SITE PLAN AND TRAFFIC ADVISORY REVIEW COMMITTEE
Internal Staff Meeting
Minnesota Valley Room, First Floor, Intergovernmental Center

Meeting Date: 01/13/2026

CY01-26

Request of HTG Architects, on behalf of the owner, Blaze Credit Union, for a conditional use permit to allow a drive through with driving lanes between the building and the property frontage in the Highway Gateway Overlay District; for a certificate of design compliance for the construction of a new, approximately 6,830 square foot structure in the Highway Gateway Overlay District; for a preliminary and final plat review of Blaze Mankato Addition; and for the vacation of a portion of a 10' utility easement located between Lots 1 and 2, Block 1, as per the recorded plat of Mills Addition to Mankato. The subject properties are described as Lot 2, Block 1 and the north 132.20 feet of Lot 1, Block 1, Mills Addition to Mankato (BEC PID R010909227005 and R010909227003, 1831 Premier Drive).

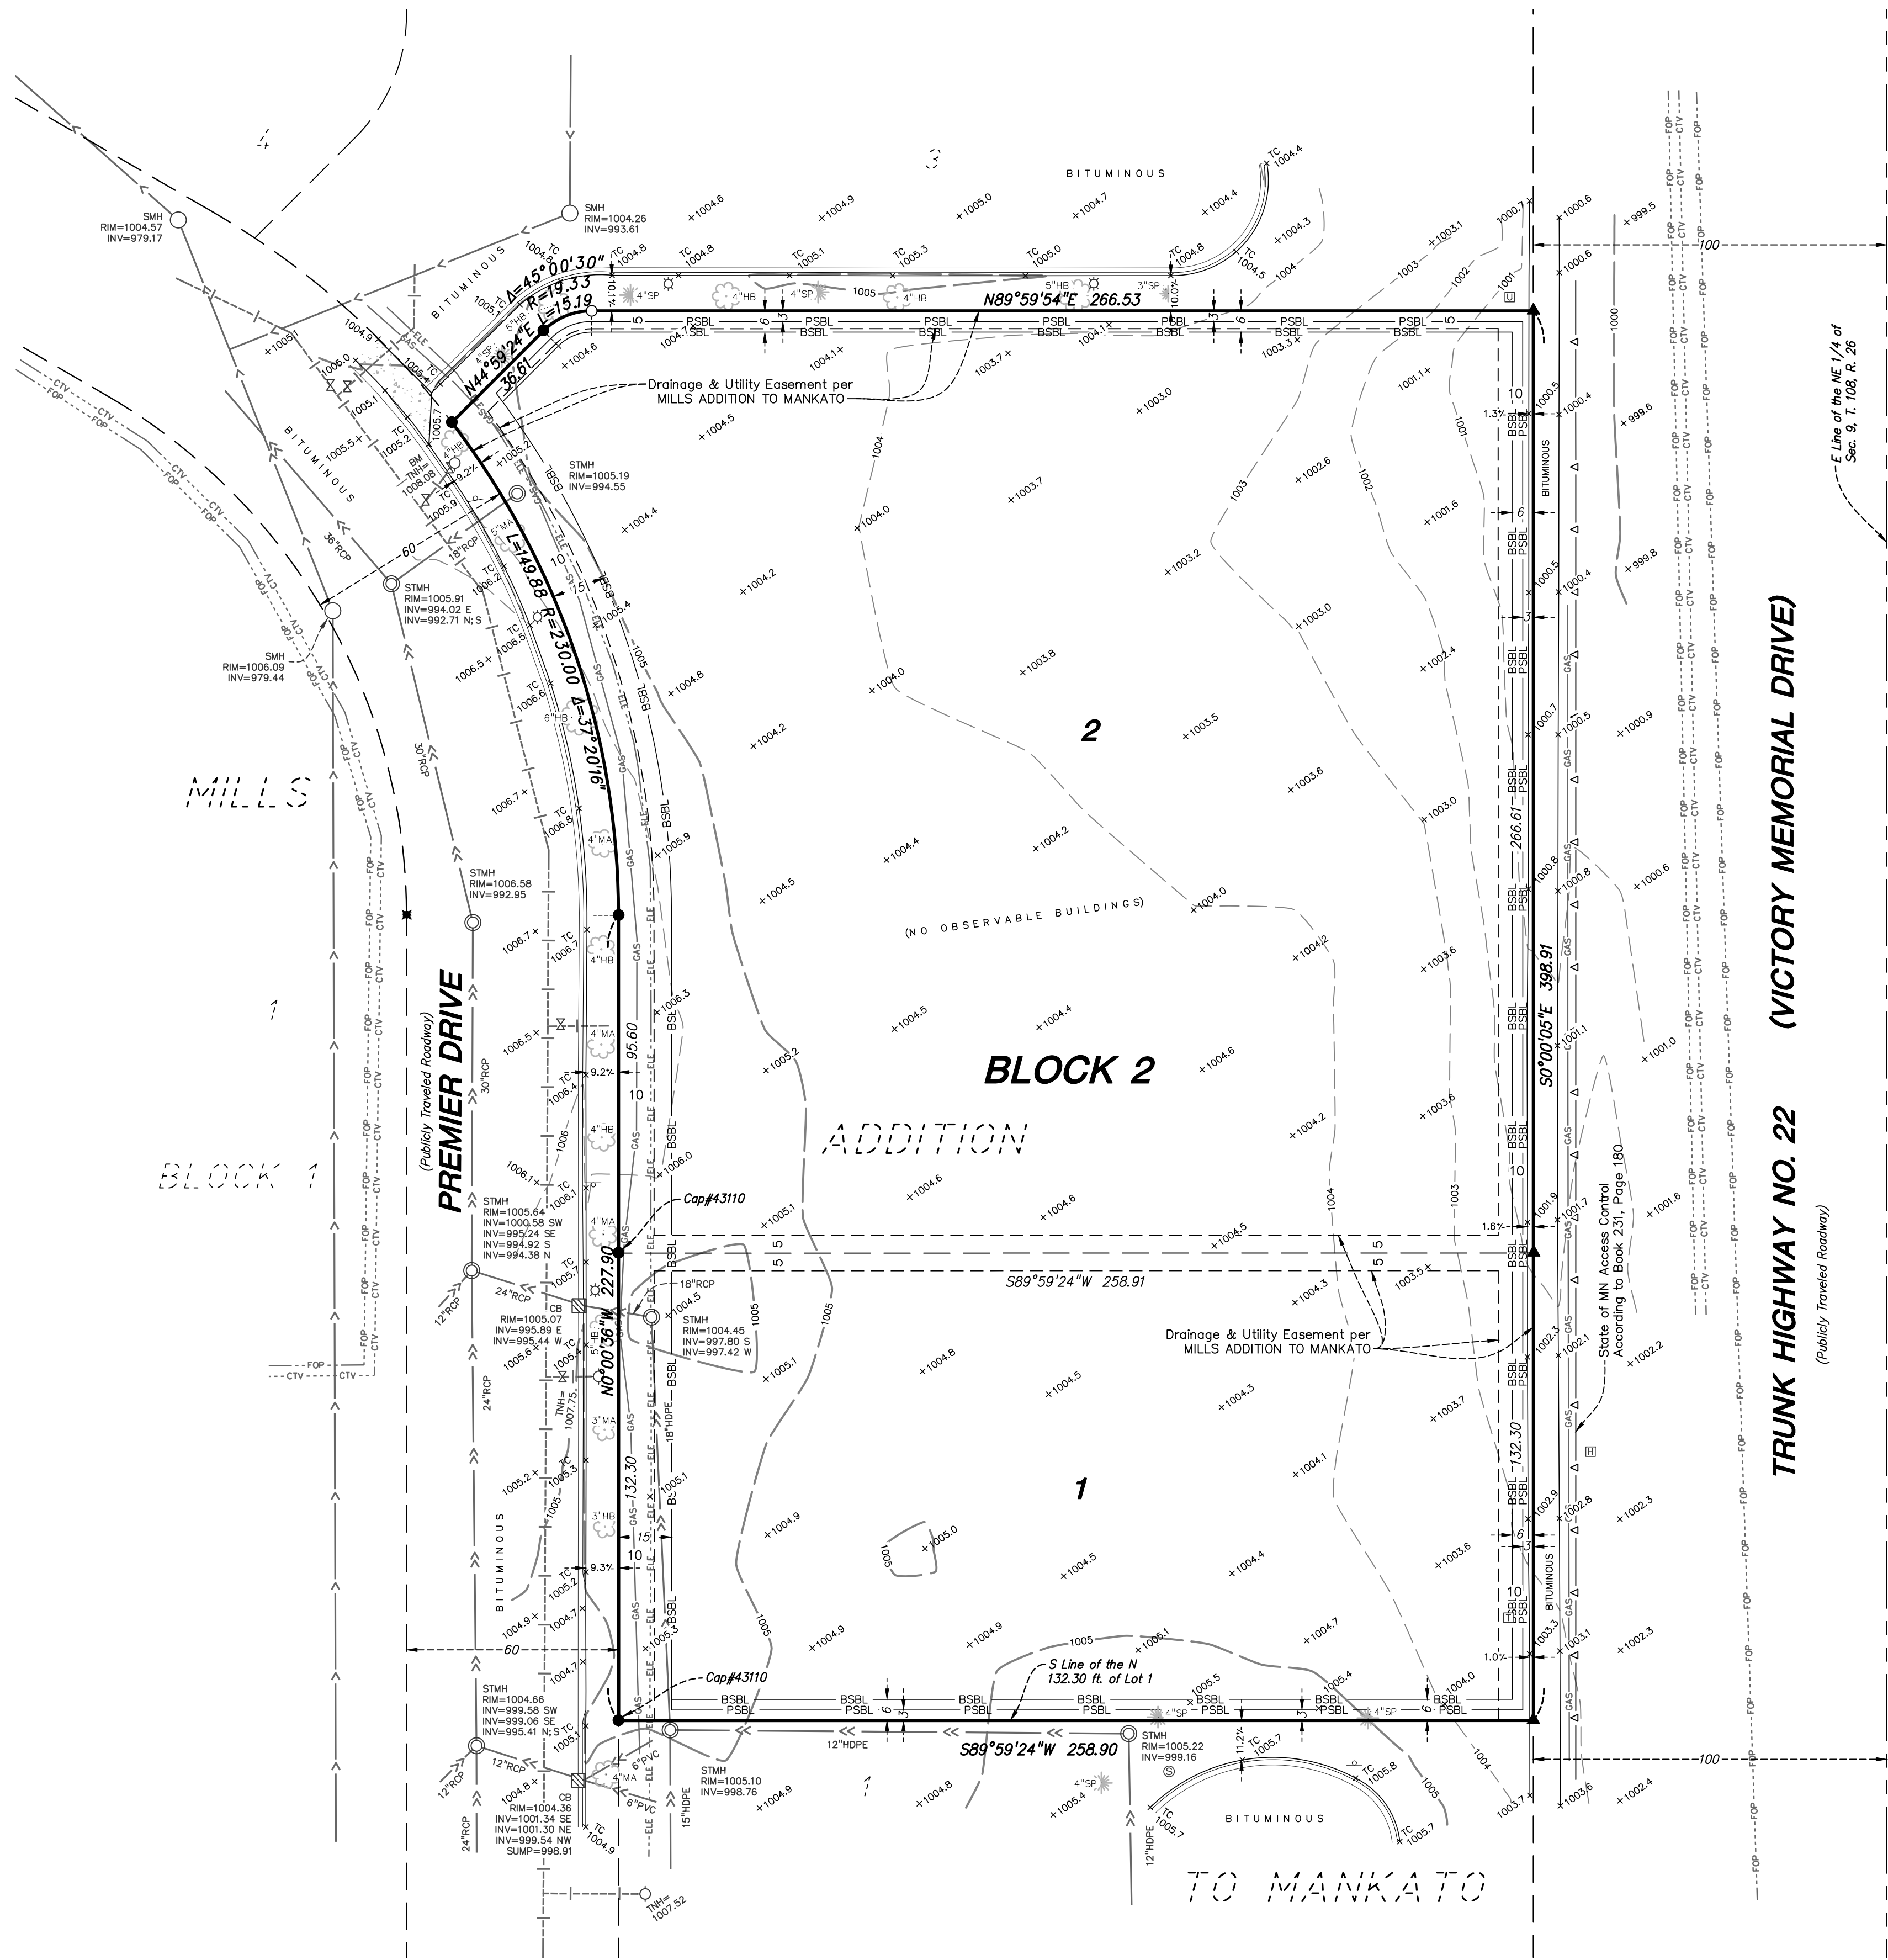
The proposed development is estimated to generate between 500 and 700 daily trips to / from the site. These trips would be distributed along Premier Drive to the north / south and eventually utilize Victory Drive and / or Hwy 22. Future ADT volumes along adjacent roadways within the study area, with the additional traffic from the proposed development, are expected to continue to be well under capacity. In addition, the peak hour site trip generation represents one (1) or two (2) additional vehicles per minute along Premier Drive; this level of peak hour trip generation is not expected to impact corridor / intersection operations or result in any significant change in area queuing. Thus, no infrastructure improvements are needed to support the proposed development from a capacity perspective.

SITE PLAN REVIEW

A preliminary review of the proposed site plan does not indicate any significant issues with respect to drive-thru stacking, circulation, or parking. Thus, the following site plan items are offered for consideration or further discussion:

Figure 1

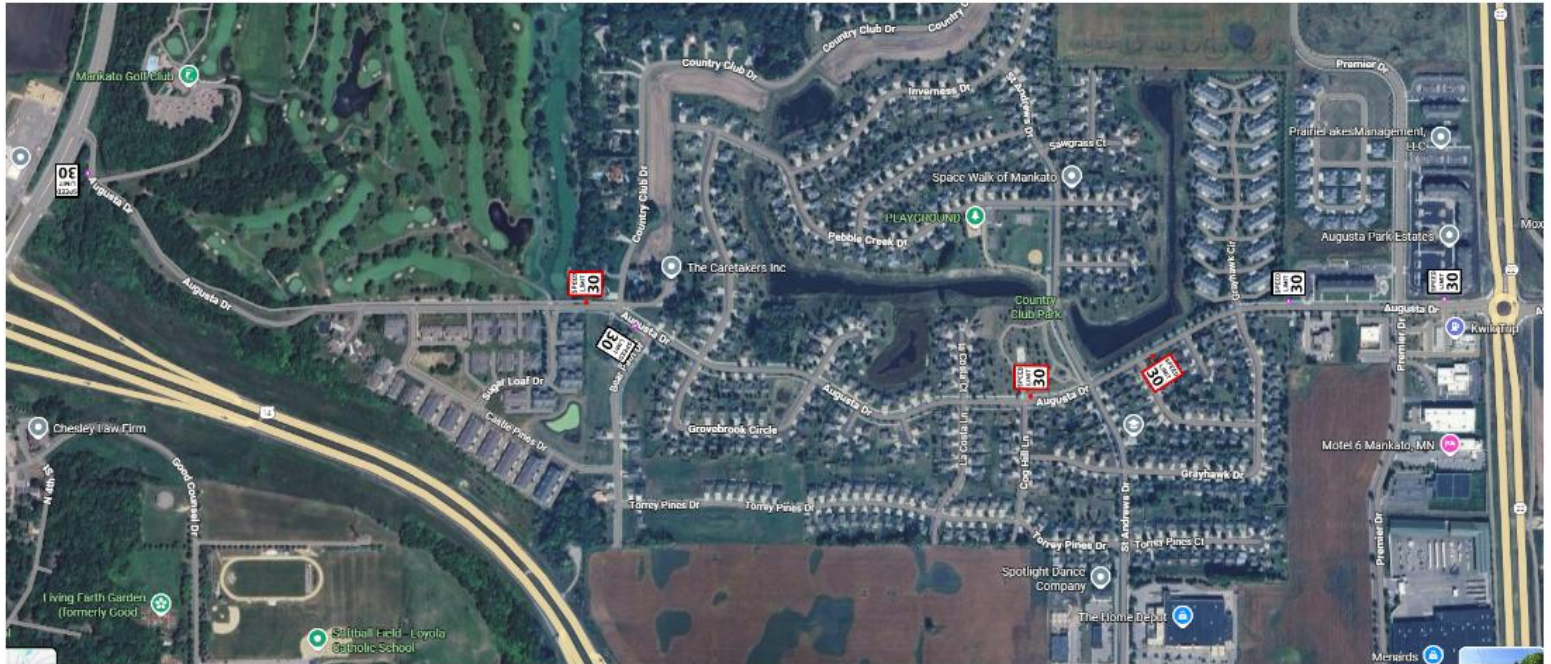
The recommendation comes after receiving concerns of speeding along Augusta. Staff's review confirmed that Augusta is posted appropriately at 30 MPH, however, additional signage could provide benefits by informing drivers of the regulatory speed limit at the strategic locations shown in **Figure 1**.

Figure 1

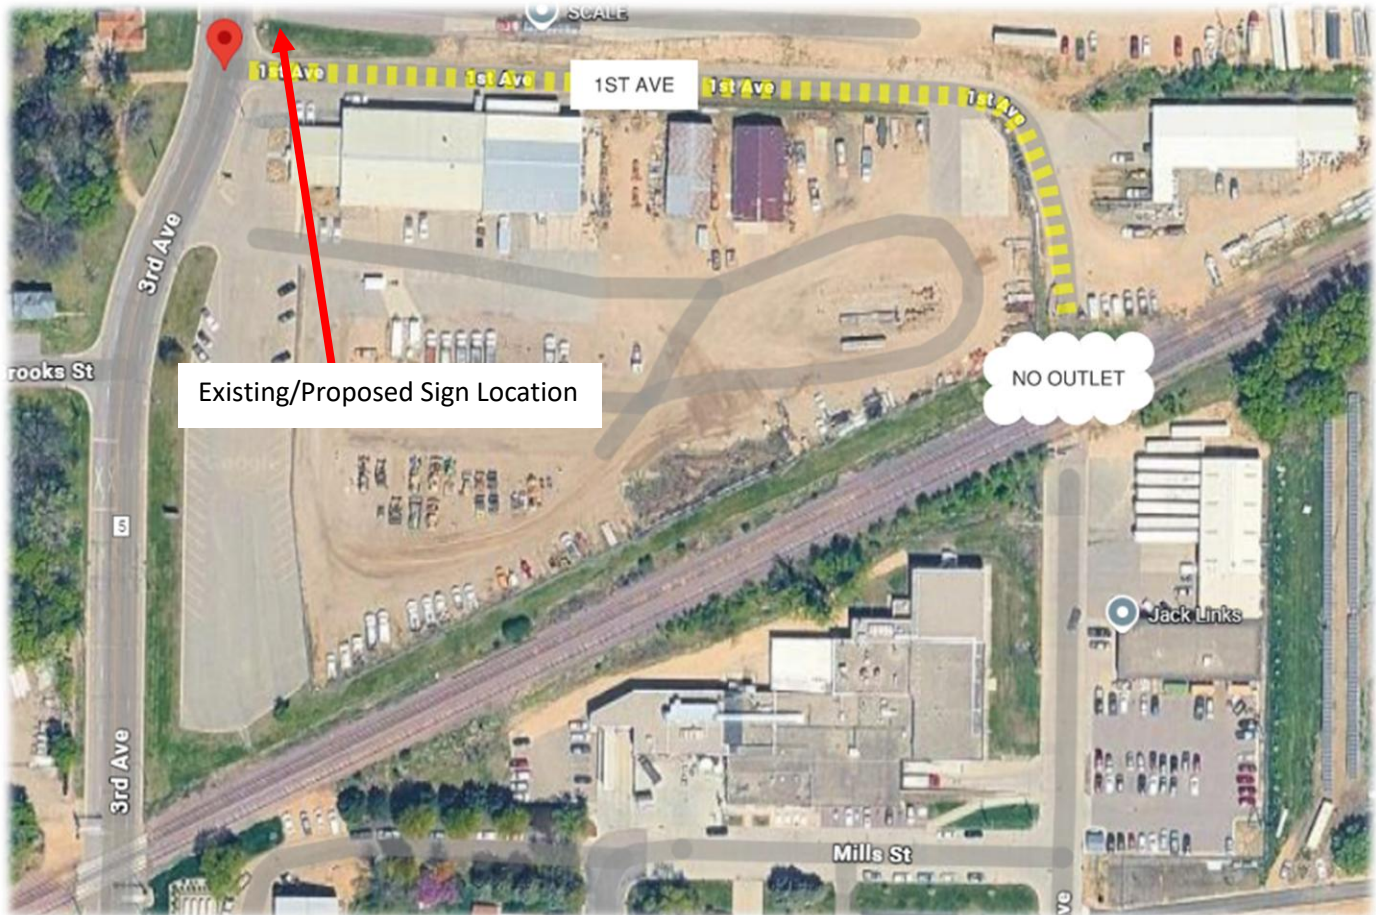
This recommendation addresses concerns raised by local business regarding large commercial vehicles entering 1st Avenue and then needing to back out after discovering it is a no-outlet street. Due to the roadway alignment, drivers cannot see that 1st Avenue has no outlet until they are fully committed, creating operational and safety issues when backing out along the street. (See Figure 1.)

Figure 1

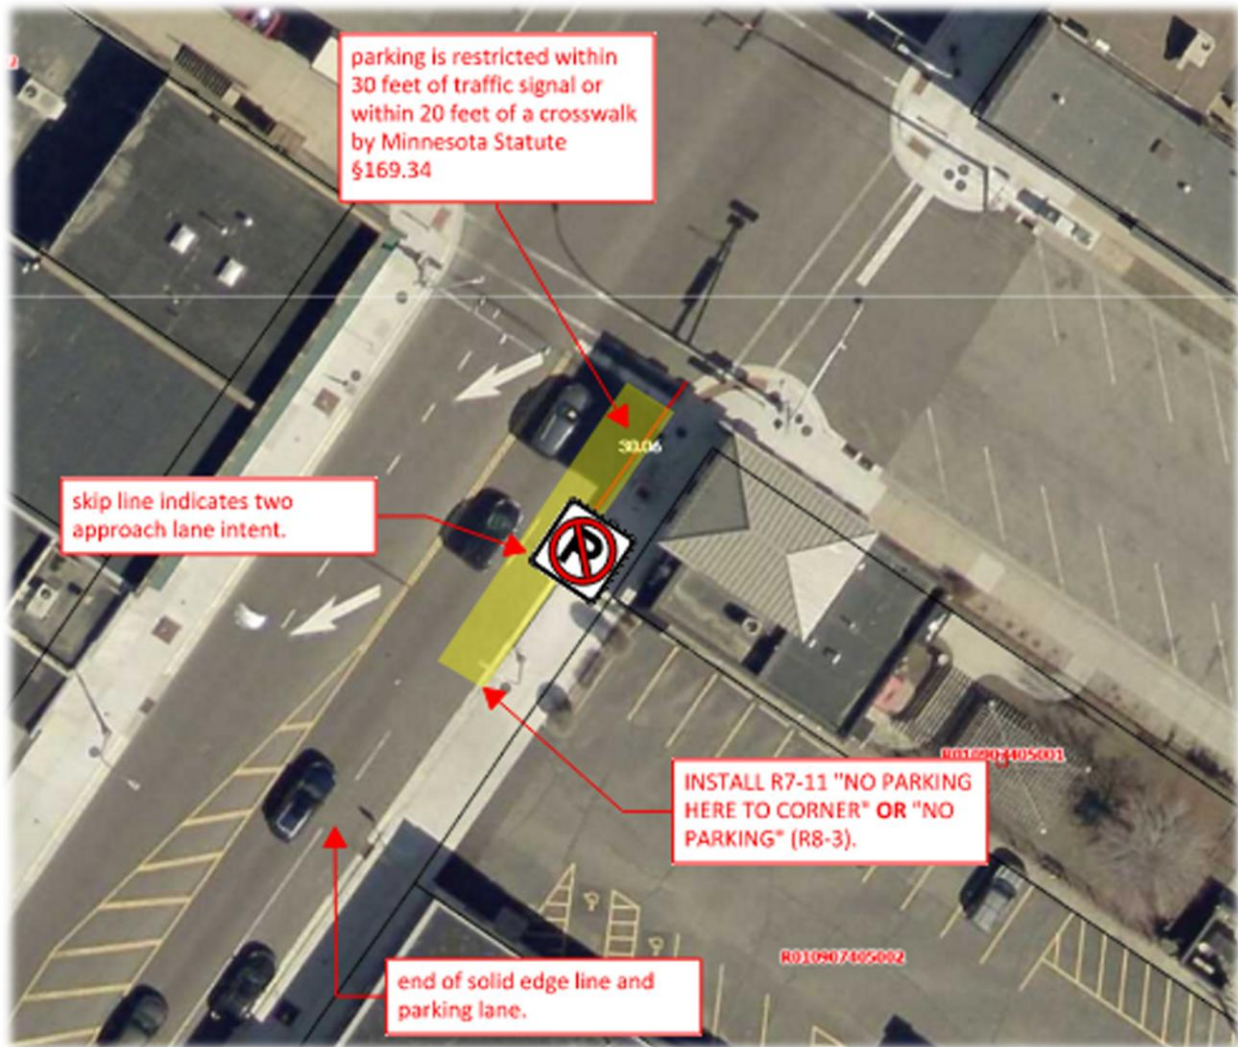
This recommendation follows citizen concerns that vehicles have been parked in the signal approach lane. Staff's review confirmed that existing pavement markings designate this space as a travel lane adjacent to the curb, not a parking lane. A photo provided by the citizen further verifies that the area is currently being used for parking. See Figure 1 for the recommended parking restriction zone. The owner of Mom & Pop's Ice Cream at 629 N Riverfront Drive has been contacted regarding the proposed sign installation and is supportive.
